Site Instruction

SI 26

PROJECT : Hampton Manor
PROJECT No : 1136.13
DATE : October 10, 2018

Title: Addition of Roof Scuppers

ROYAL PINES HOMES

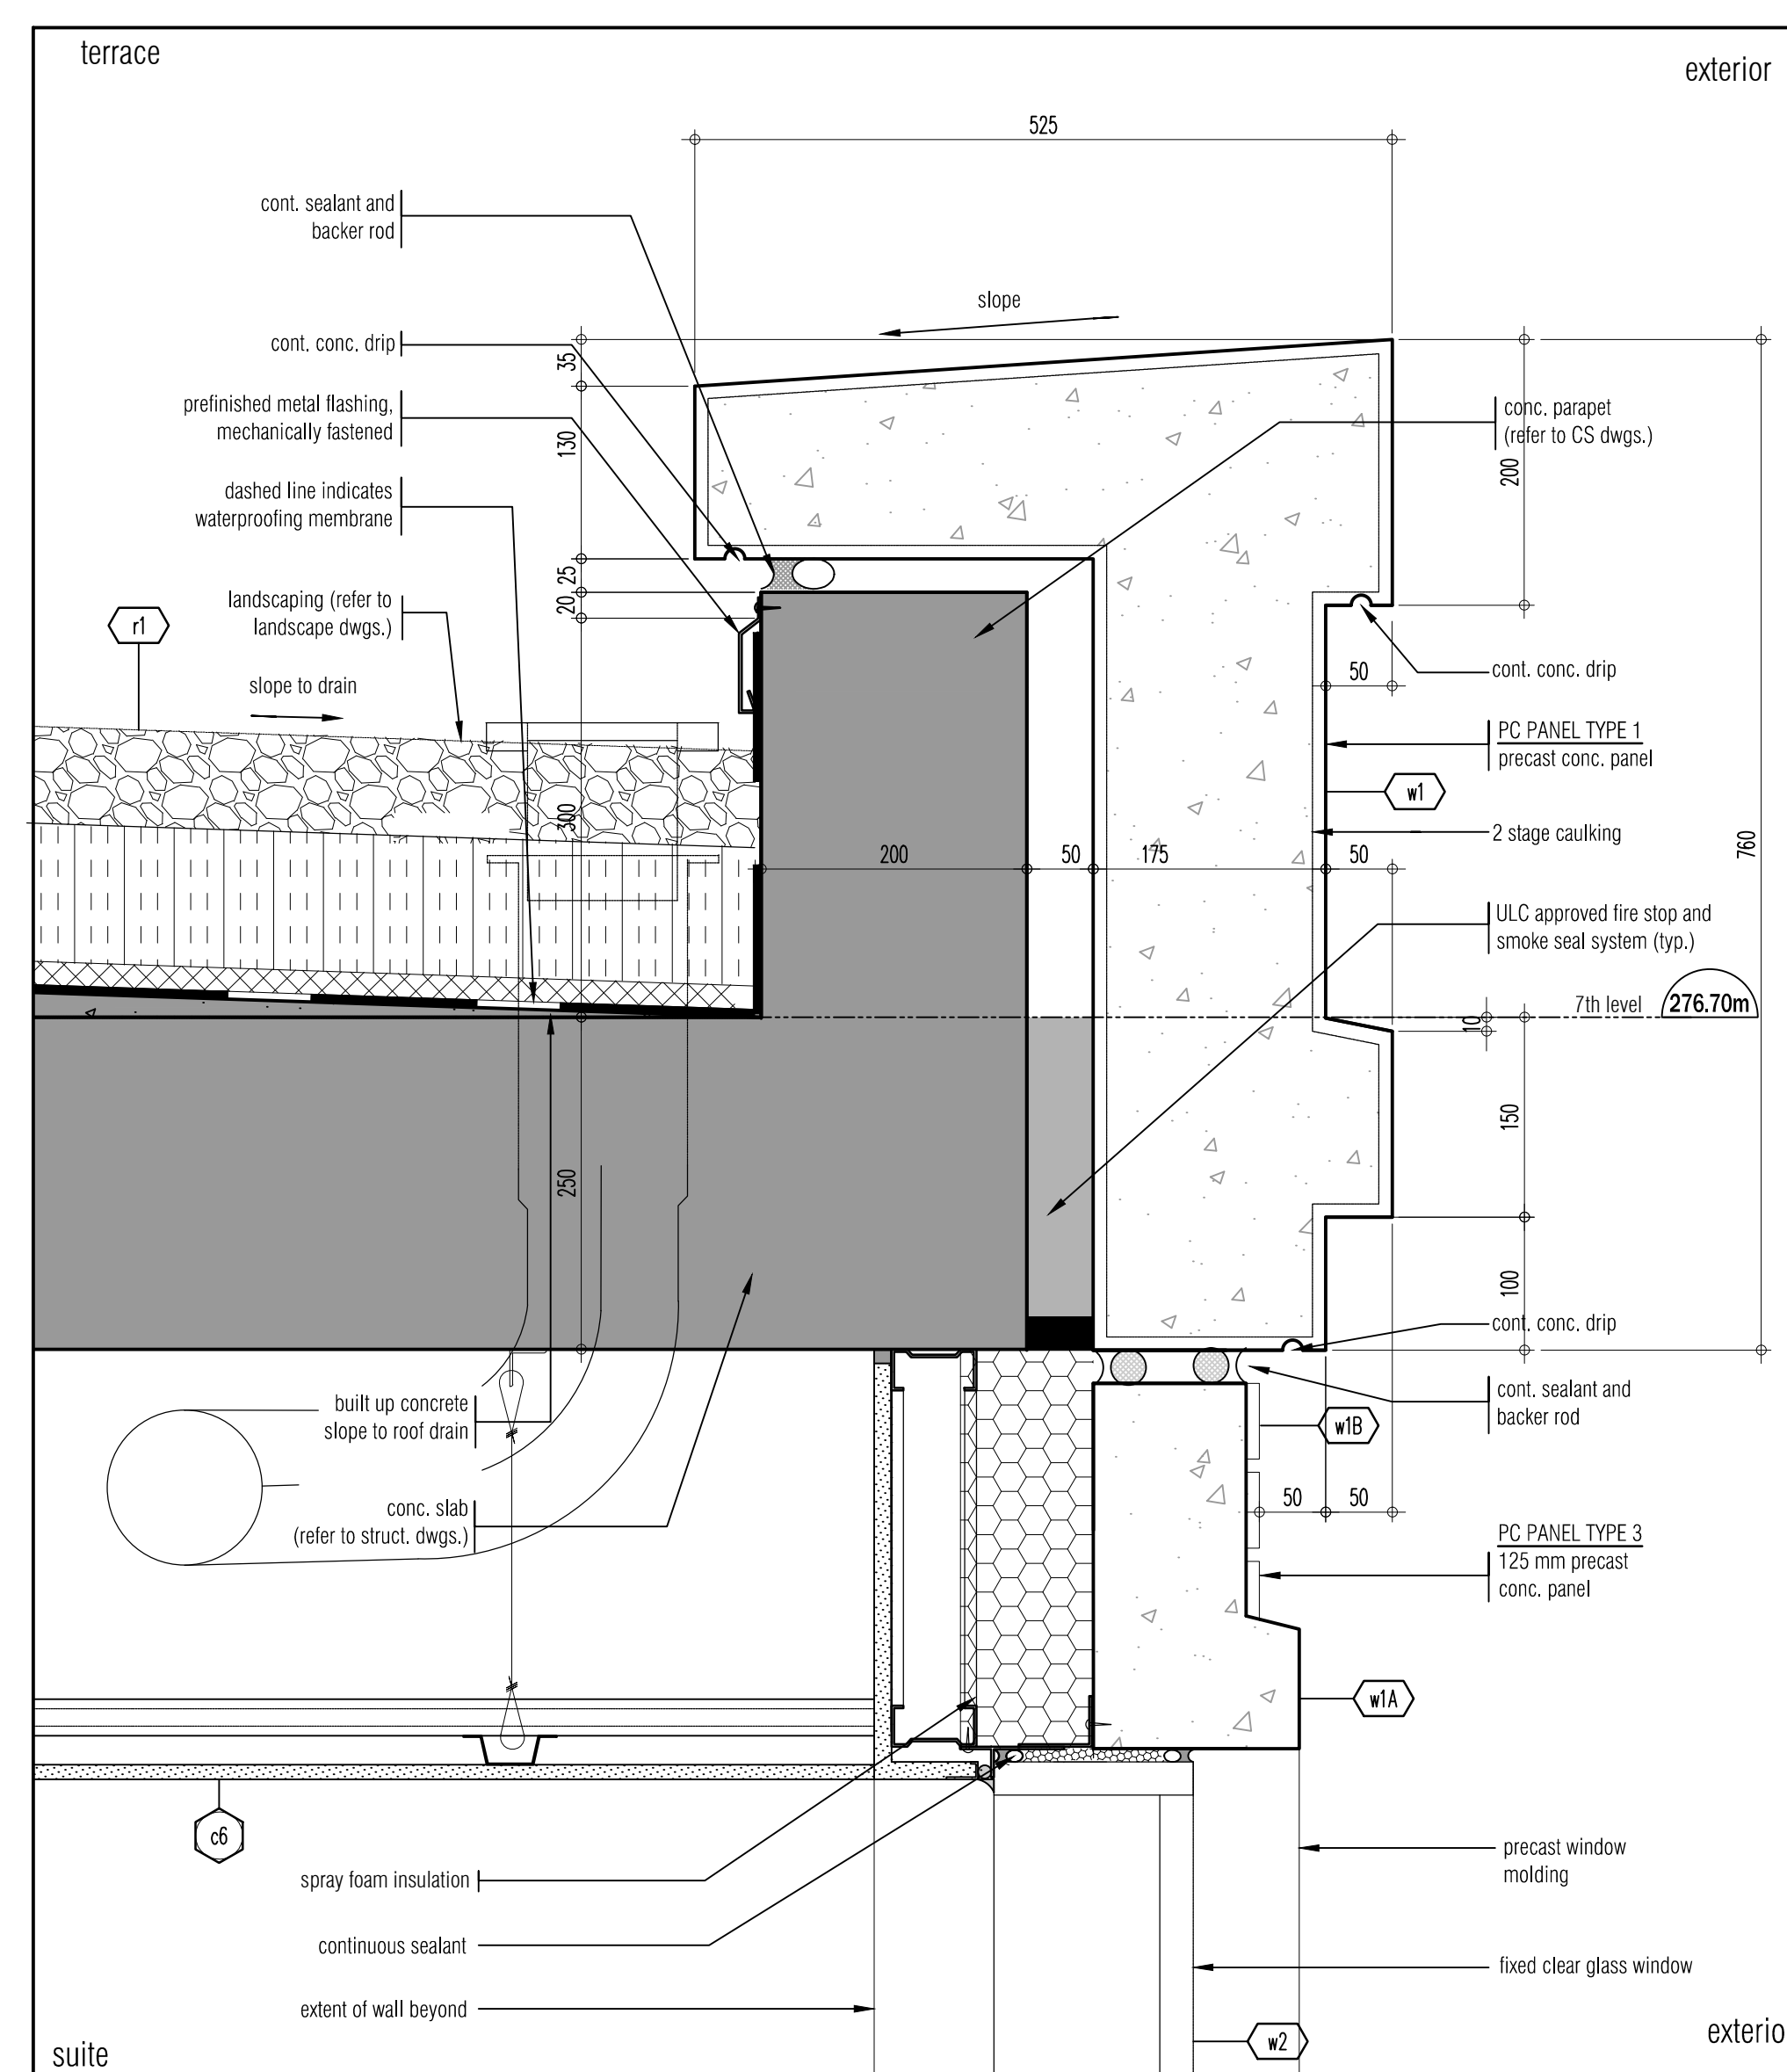
A401a-A401c – Building Elevations

- Adding Scuppers to Roof curbs
